ADDENDUM NO. 1
to
PLANS and SPECIFICATIONS
for

Medina River Sewer Outfall, Segment 4
SAWS Job No. 12-2504

Issue Date: November 14, 2011

JOB NO.	6866-00
DATE	FEBRUARY 2010
DESIGNER	RRD
DRAWN	BMO
CHECKED	IJC
DRAWING No.	C-76
SHEET No.	17

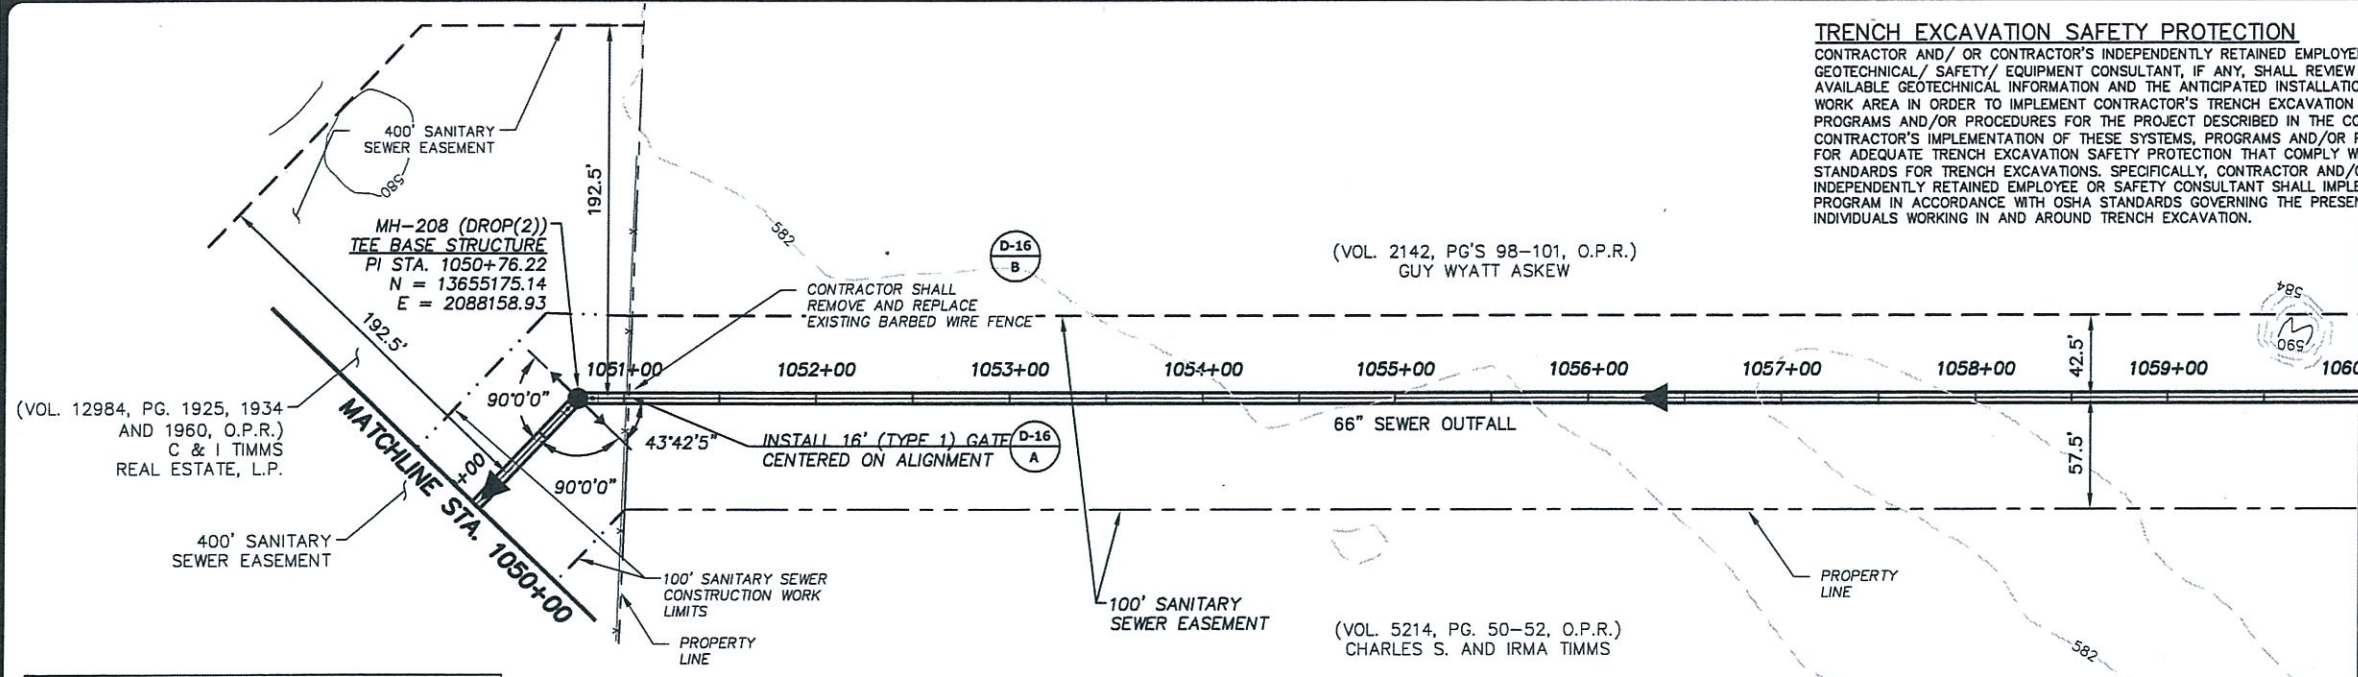
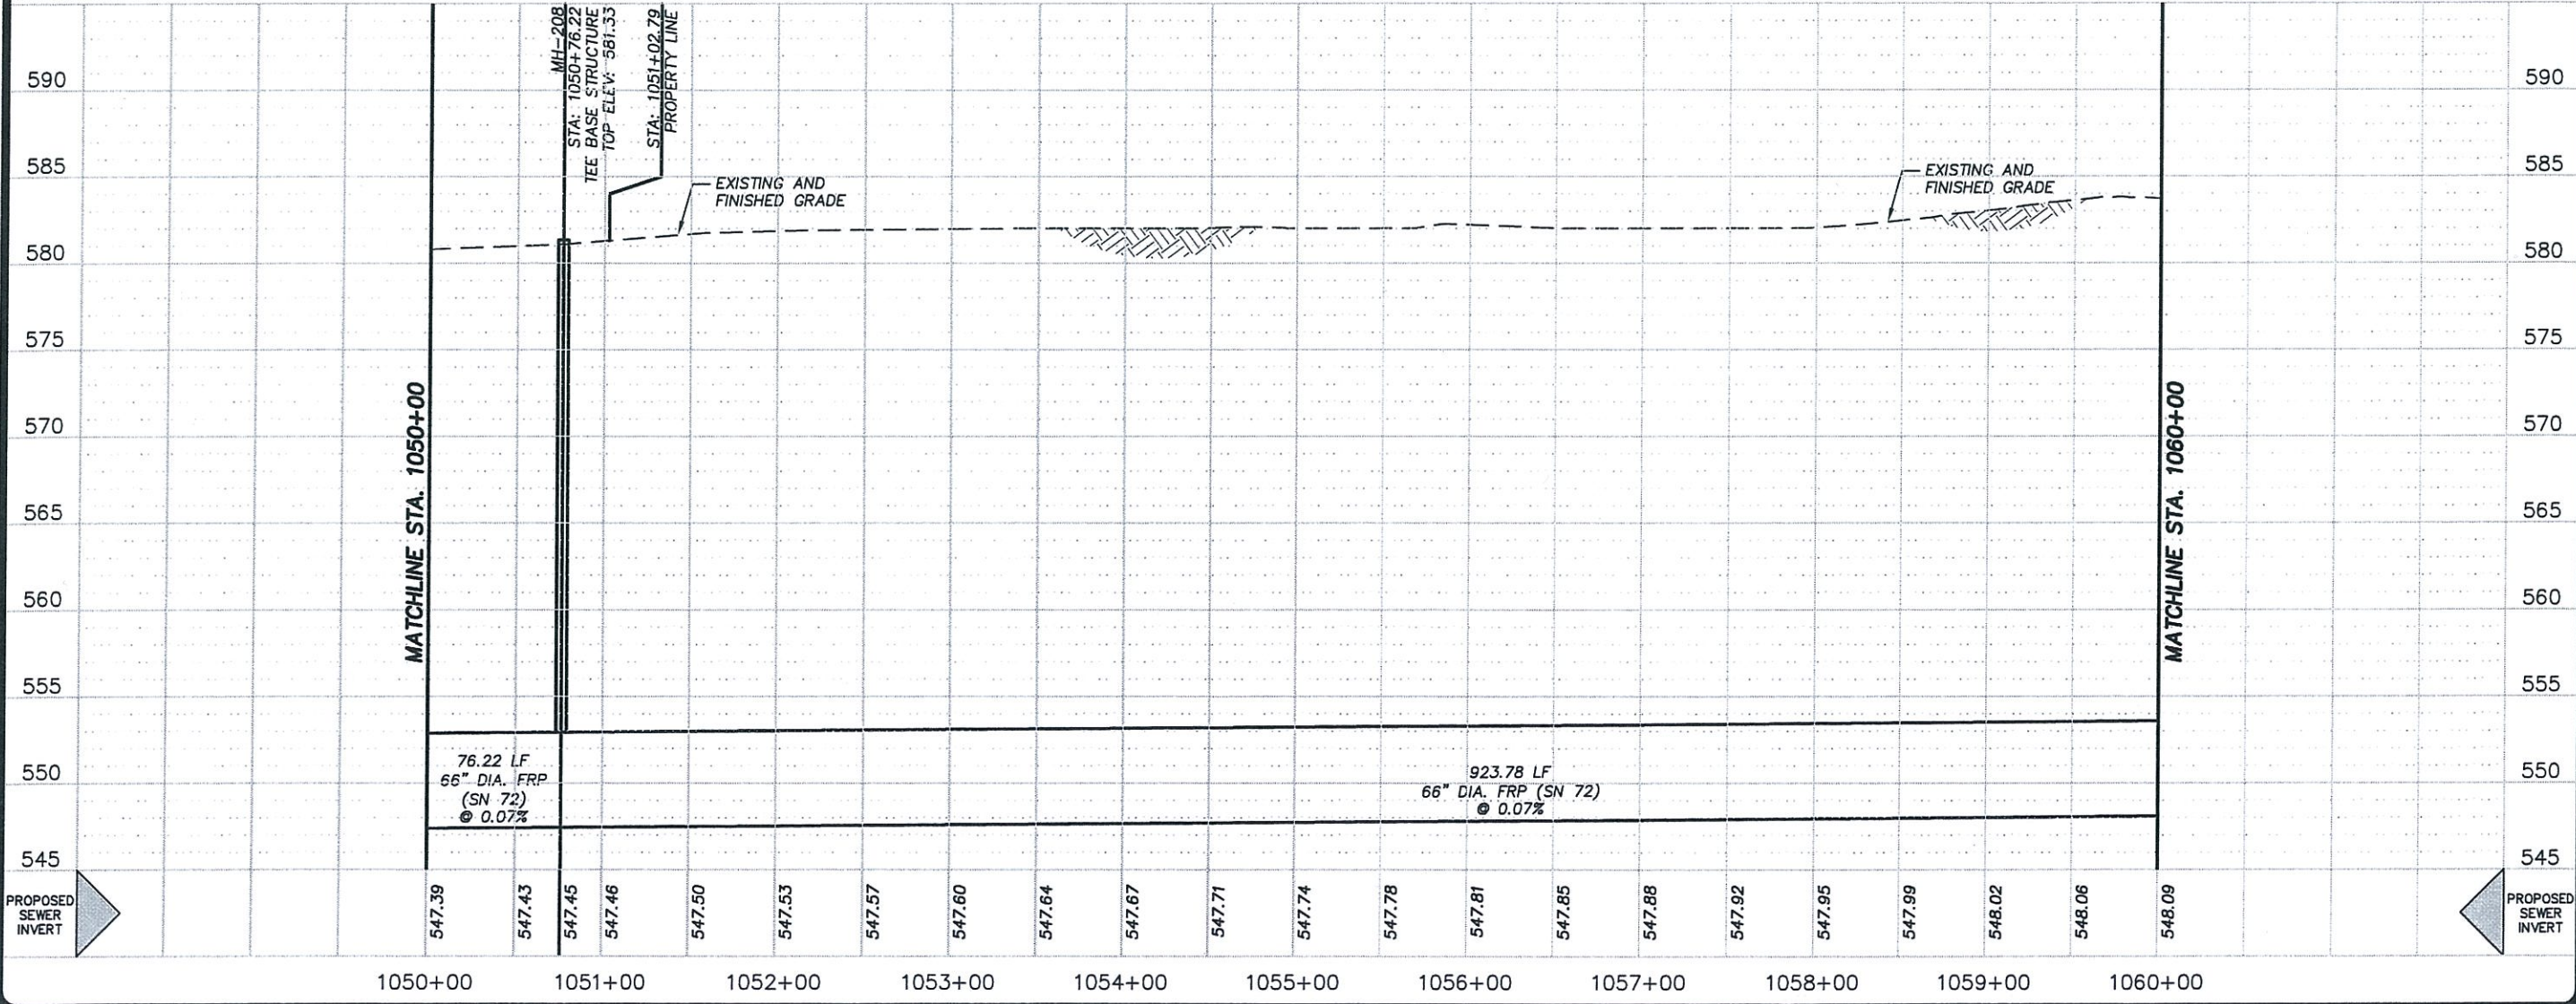
C. Drawing No. C-76, Sheet No. 17 – A 100' Sanitary Sewer Construction Work Limits has been added to plans. Remove and Replace this sheet with the attached plan sheet

JOB NO.	6866-00
DATE	FEBRUARY 2010
DESIGNER	RRD
DRAWN	BMO
CHECKED	IJC
DRAWING No.	C-75
SHEET No.	16

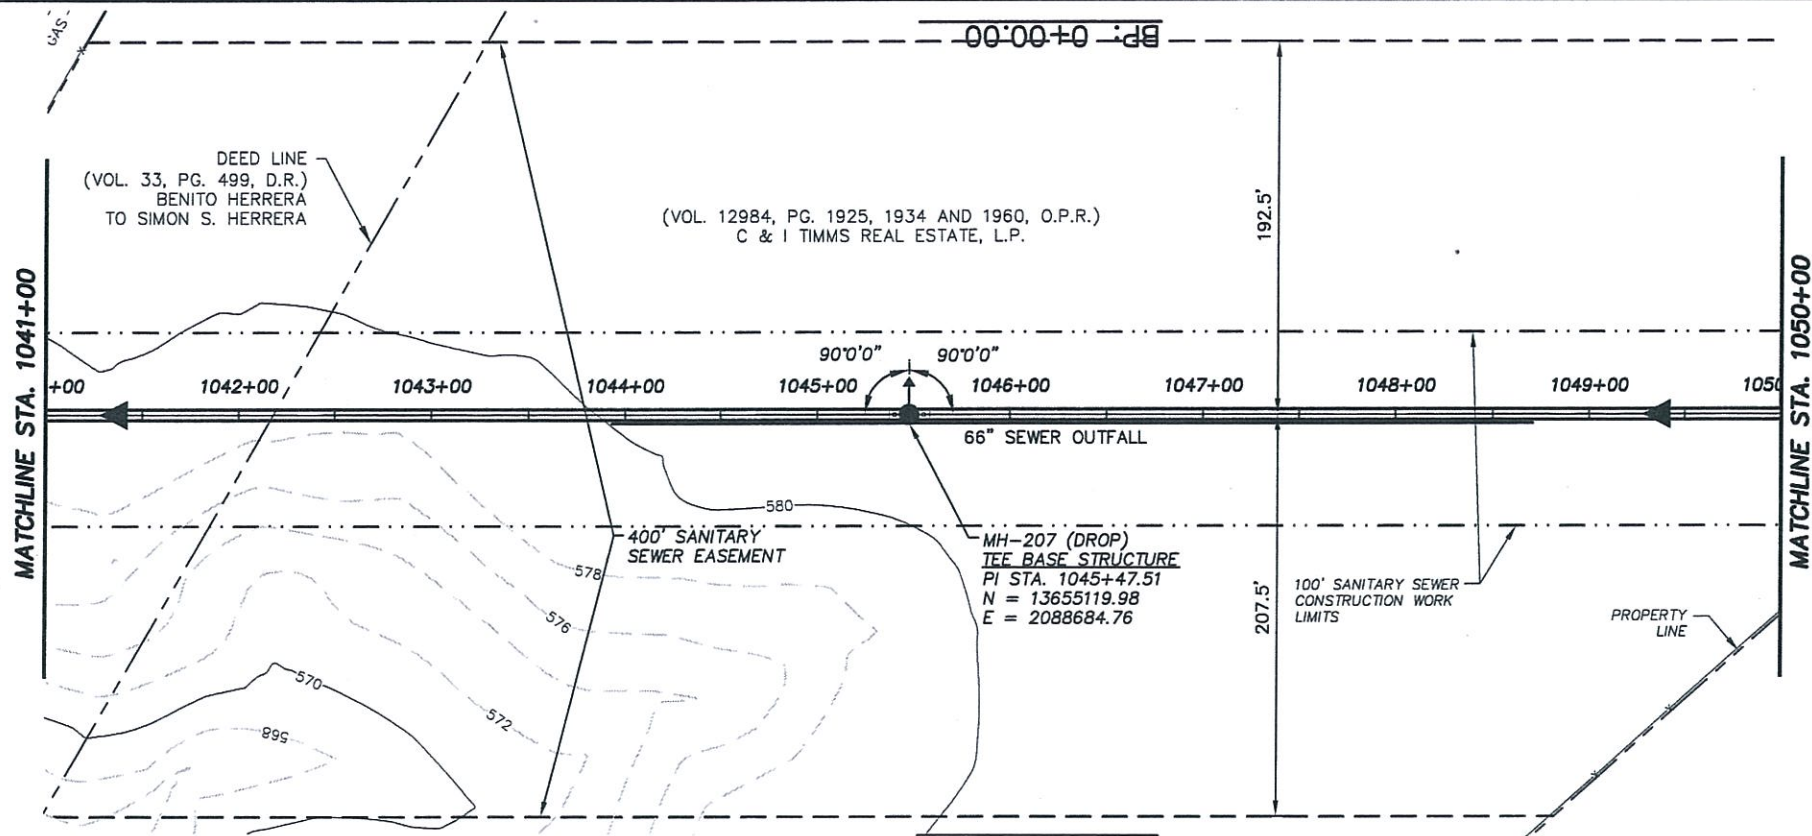
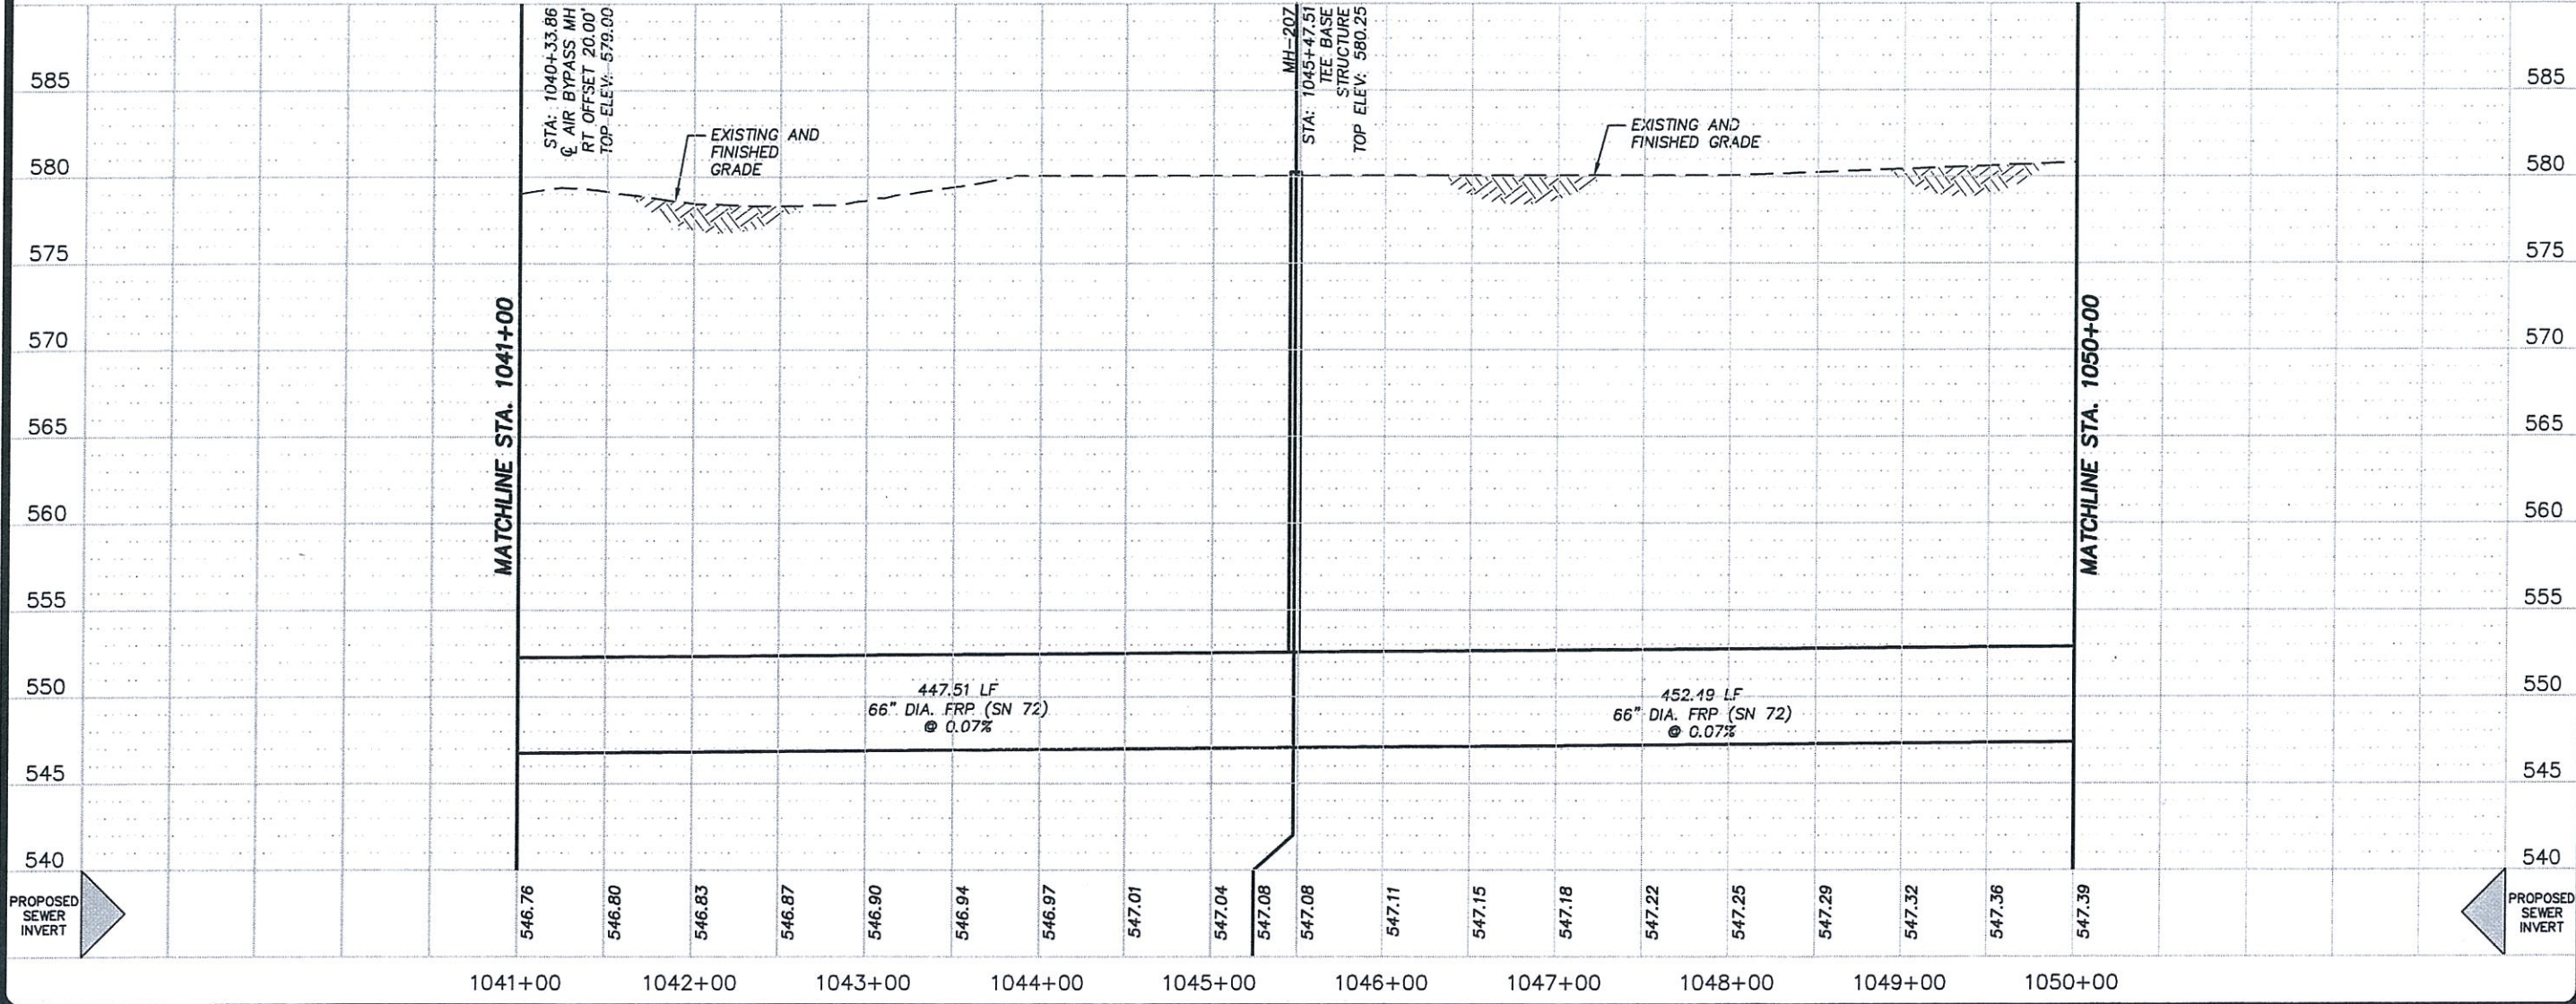
B. Drawing No. C-75, Sheet No. 16 – A 100' Sanitary Sewer Construction Work Limits has been added to plans. Remove and Replace this sheet with the attached plan sheet.
